Design Review Commission Report

Meeting Date: Thursday, November 7, 2013

Subject: **710 North Camden Drive (PL1305756)**

A request for an R-1 Design Review Permit to allow for construction of a new two-story single-family residence located in the Central Area of the City north of Santa Monica Boulevard. The Commission will also consider adoption of a Categorical Exemption, pursuant to the California Environmental Quality Act.

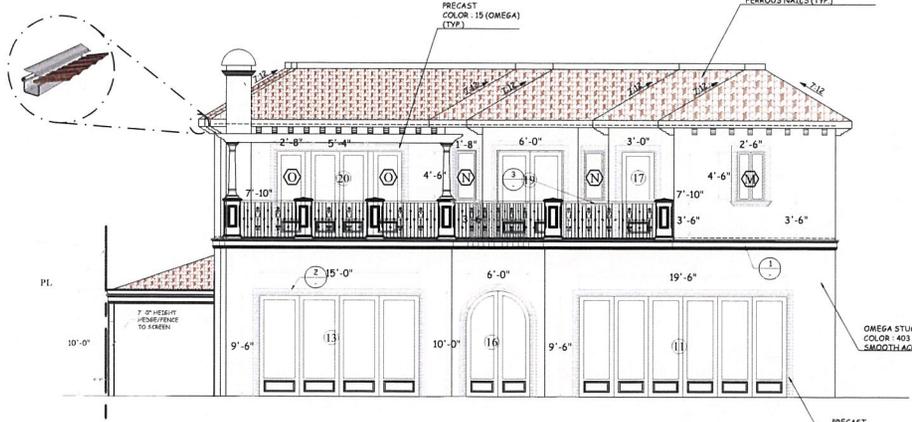
two story central elements adds to the verticality

look at a more single story approach to the window above the door

revisit the design of the roof overhang and rafters

the roof looks heavy on the house

the house read all the same across, all the same size . Is it symmetrical? it looks skewed, if you are going to make it symmetrical do it, and if not don't. this in somewhere in-between

If you use classical motifs in the center with precast it needs to have some variation across it

The fence is common, too generic. Think about the fence creatively

Don't understand the skinny arches

There are a lot of doors, no windows. There needs to be less doors, more windows

In this design the house does not reduce scale of bulk and mass

Too much like Box with too many openings and central element makes it too vertical

-Window above has been modified to have a more single level design. The window is now more than 2 feet shorter, and is wider, this helps eliminate verticality. Wood detail has been added to the window glazing to create an even more horizontal approach.

-The center section of the roof has been set back 8 feet creating more uniformity and helping reduce the appearance of scale and height . The roof doesn't appear to be heavy and bulky with this new approach.

-The center element has been moved toward the south side of the street,

-The building has been broken into a 3 and 2 modulation separated by the entry

- Per the commission's suggestion the design team along with the owners met with Mr. Crouch to discuss how to improve the overall design. One of Mr. Crouch's suggestions for resolving the issue with symmetry was to have three doors on one side and two on the other. This way the asymmetry of the design is more prominent.

- One of Mr. Crouch's suggestions for improvement was to add a spiral column in the design of window above the entry. This would add variation to the classical design while still staying true to the Tuscan design principles.

-the fence follows with the simplified Tuscan tradition in order to keep the design internally compatible.

-the window and frame above the entry has been modified to be shorter and less vertical.

-Planters have been added in front of the second story doors creating a more single story approach by breaking up the doors while still maintaining the owners needs for access to the exterior. From the exterior the doors appear like windows because the planter and railing divide the length of the door, where the lower half is barely visible at all

-Set back central entry 8 feet from previous design
